DOCUMENT 009113 - ADDENDA

- A. Addendum No. Two.

- A. Project Name: Skatium Locker Room Renovation.
- B. Owner: Township of Haverford.
- C. Owner's Representative: C.B. Development Services, Inc.
- D. Architect: BKP Architects.
- E. Date of Addendum: October 4, 2024

Skatium Locker Room Renovation
Responses to Bidder Questions and Written Identification of Modifications to Project Documents

DRAWING NO:
A-001

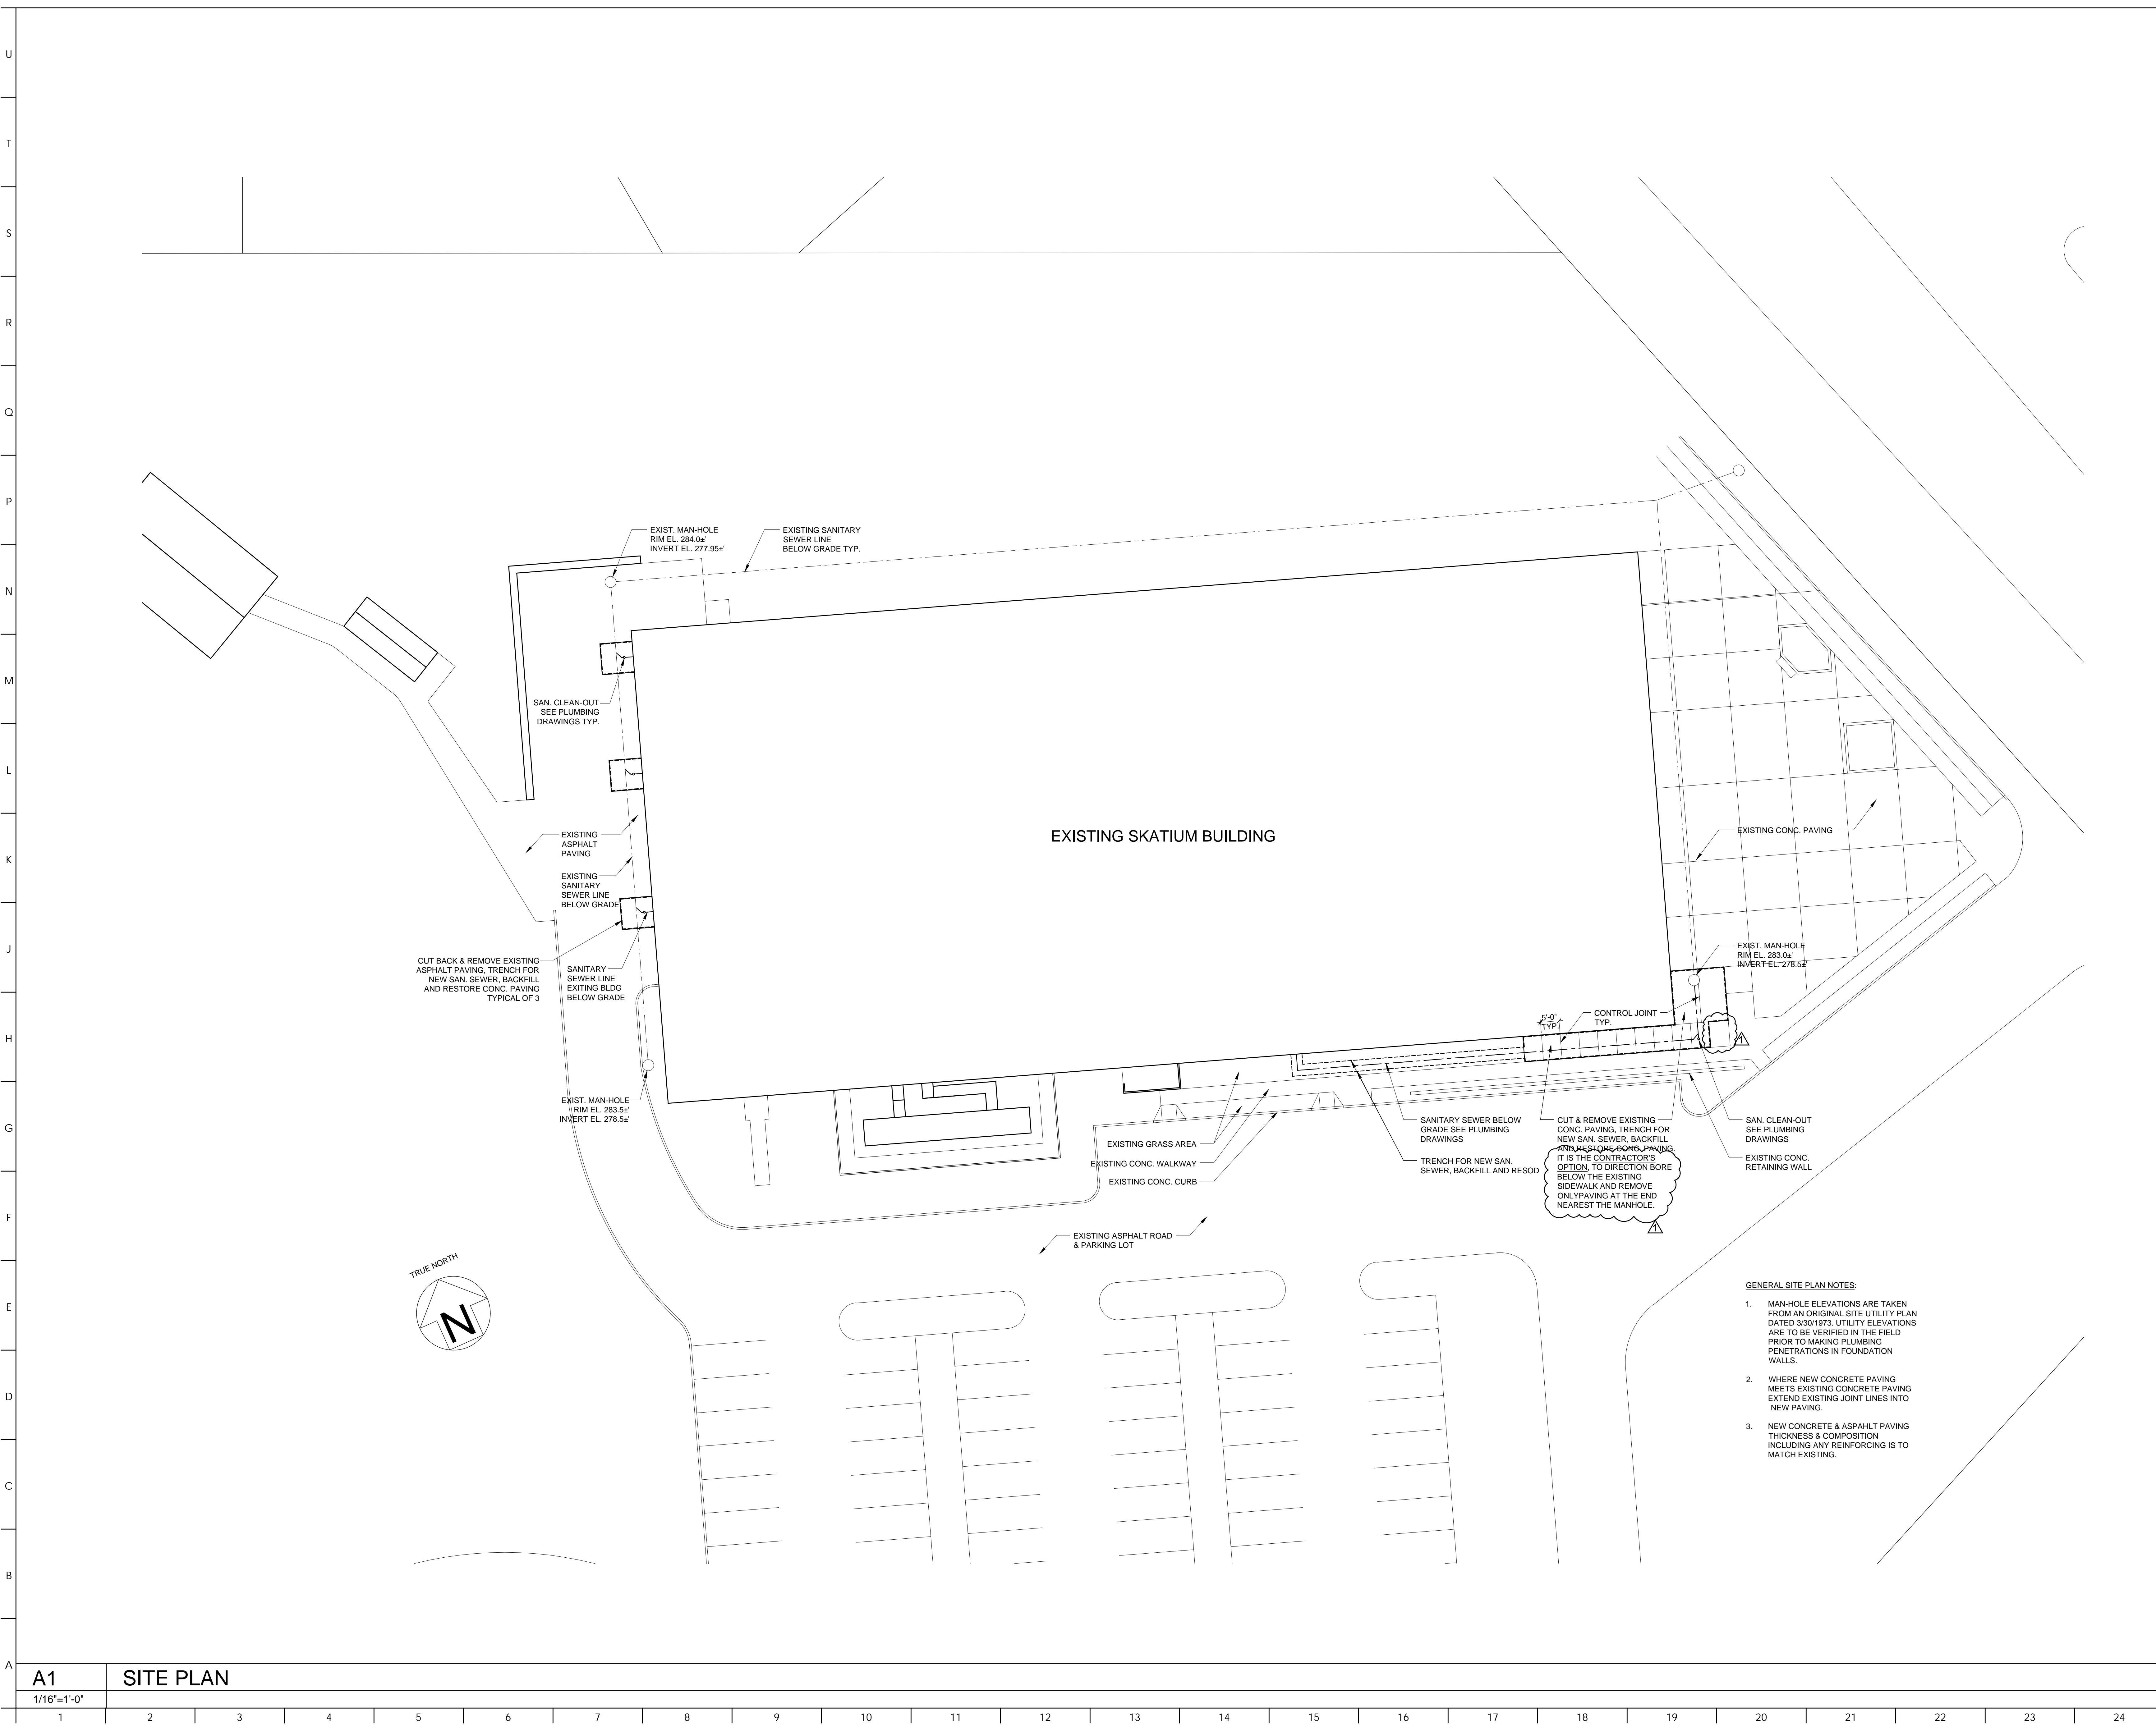
- G. Drawing G-003 has been added.
- H. Drawing A-001 has been modified to include Contractor option to direction bore instead of excavation for new sanitary line.

L1 HARDWARE SCHEDULE

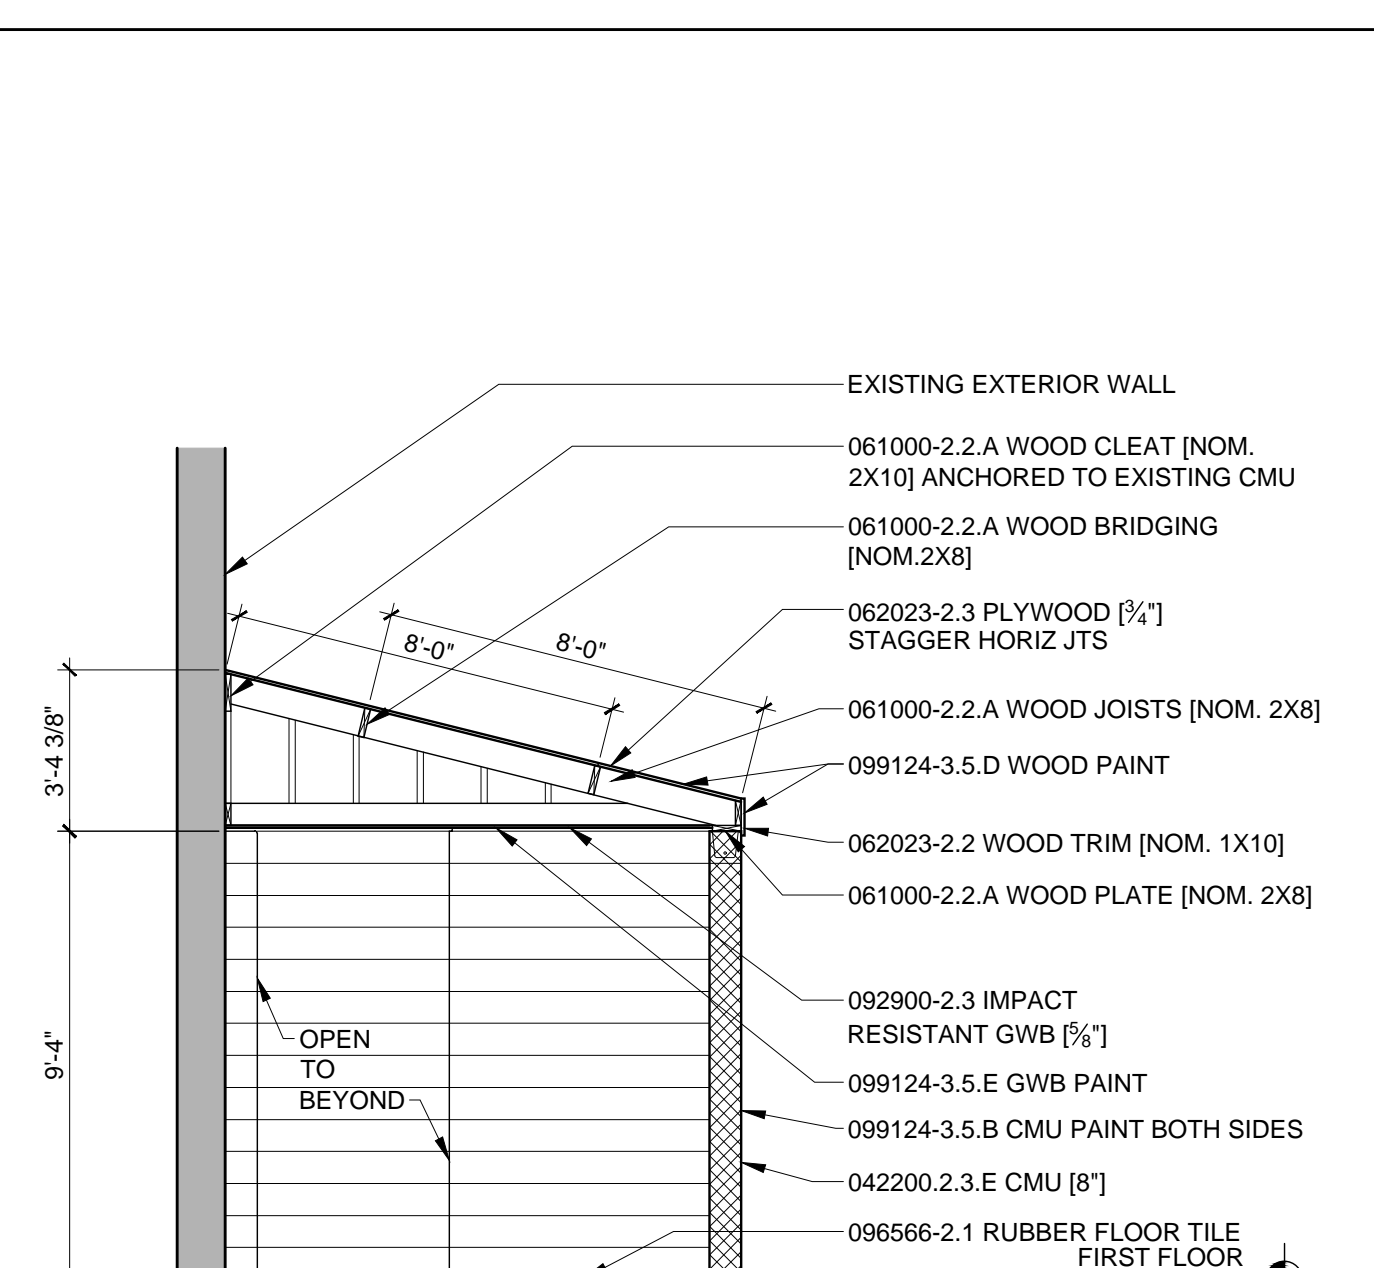
7. The hardware schedule on Drawing A-101 is incomplete. It only lists hardware for 6 openings. There are no hardware sets for openings 101.1, 102.1, 103.1, 104.1, 107.1 and 108.1. Please advise.

- I. Drawing A-101 has been modified to include missing door hardware sets.
- J. Drawing A-601 has been modified, removing references to Sheet A-100, replaced with reference to Sheet A-701.

Hardware schedule has been revised on A-101, Rev 1, dated 10-3-24 and issued with Addendum #2.
